## **Bureau of Environmental Health**

RECEIPT DATE: 4-16-15 ONSITE SEWAGE DISPOSAL	. SYSTEM P 555814
INSTALLATION APPROVAL DATE: 7/9/15 Your CONSTRUCTION	Α
PROPERTY ADDRESS: 14905 Victory Lane	
SUBDIVISION: Merwether Farm	LOT: 1 TAX ID: (1) 1593610
CONTRACTOR: Fogle's Septic Clean Inc.	EMAIL: kevin@foglesinc.com
CONTRACTOR ADDRESS: 580 Obrecht Road, Sykesville, MD 21784	PHONE: <b>410-795-5670</b>
PROPERTY OWNER: Toll Brothers Inc.	EMAIL:
OWNER ADDRESS: 14881 Meriwether Drive, Glenelg, MD 21737	PHONE: 301-418-1923
BAT UNIT MODEL: NOTICE THAT P 500 PUMP SIZE:	PUMP TANK CAPACITY: 500GPD
DISTRIBUTION SYSTEM: GRAVITY  LOW PRESSURE DOSED	NUMBER OF BEDROOMS:
LINEAR FEET REQUIRED: 222	INLET DEPTH: SEE BAT PLAN 5'
TRENCHES: TRENCH WIDTH: 3	MAXIMUM BOTTOM DEPTH: \$ 7.5'
MINIMUM SPACE BETWEEN TRENCHES: 10 EFFECT	TIVE AREA BEGINNING DEPTH: 5,5-6'
LOCATION: PER APPROVED SITE PLAN. SEWAGE DISPOSAL AREA AND BAT SURVEYOR PRIOR TO PRE-CONSTRUCTION INSPECTION.	UNIT LOCATION MUST BE STAKED BY LICENSED

Cc: Subject: 'mmartin3@tollbrothersinc.com' Meriwether Farm Lots 1, 4, 7, 8

SITE PLAN FOR BAT INSTALLATION

Fwd: Cattail: Lot #1 Blue Prints

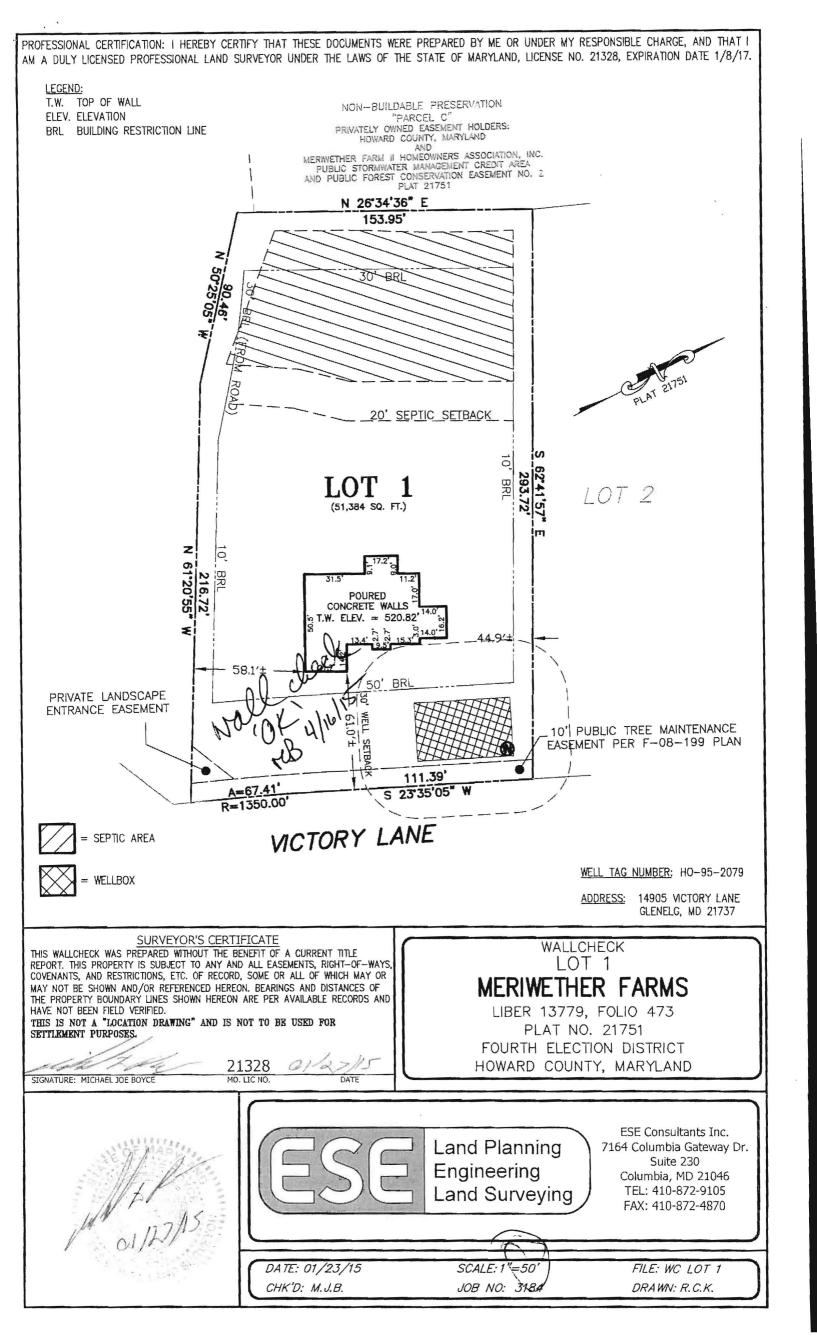
The BAT system is currently designed for 5 bedrooms but the floor plans show 6 bedrooms (guest retreat – room # 6). Please revise the floor plans or BAT Plan and resubmit for BP approval.

115/15. Per T. modd, Lot 1 BAT will be revised.

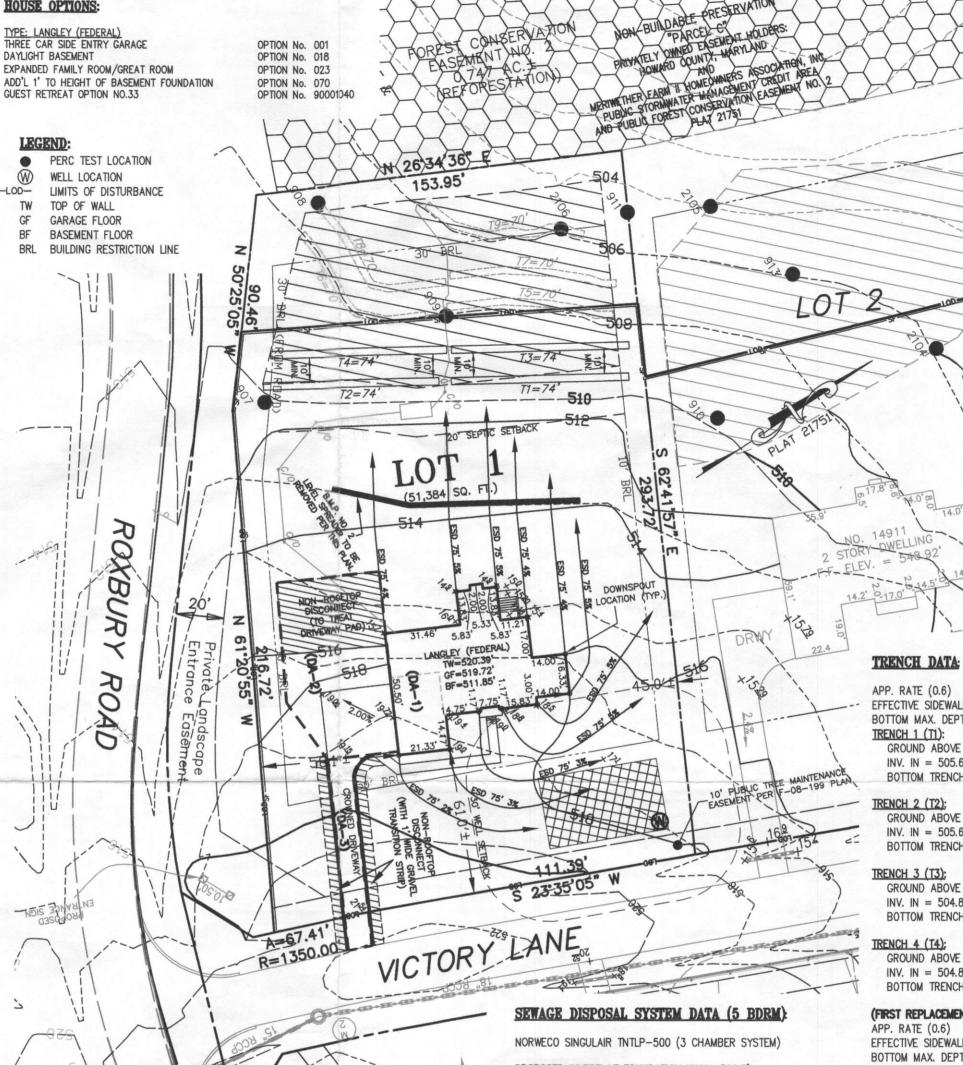
REVISED PLAN SHOWN HEREON IS TO CHANGE THE SEPTIC TANK THAT IS BEING INSTALLED ONLY. ALL CALCULATIONS ARE TO REMAIN THE SAME. THIS PLAN WAS APPROVED PREVIOUSLY WITH THE ECOPOD SYSTEM. BUT DUE TO THE MEMORANDUM FROM THE HOWARD COUNTY HEALTH DEPARTMENT DATED FEBRUARY 2015: THOSE SYSTEMS ARE NO LONGER TO BE USED IF NOT INSTALLED BY MARCH 15, 2015.

> Approved Septic System Plan Howard County Health Department Hank Osund 3/25/15
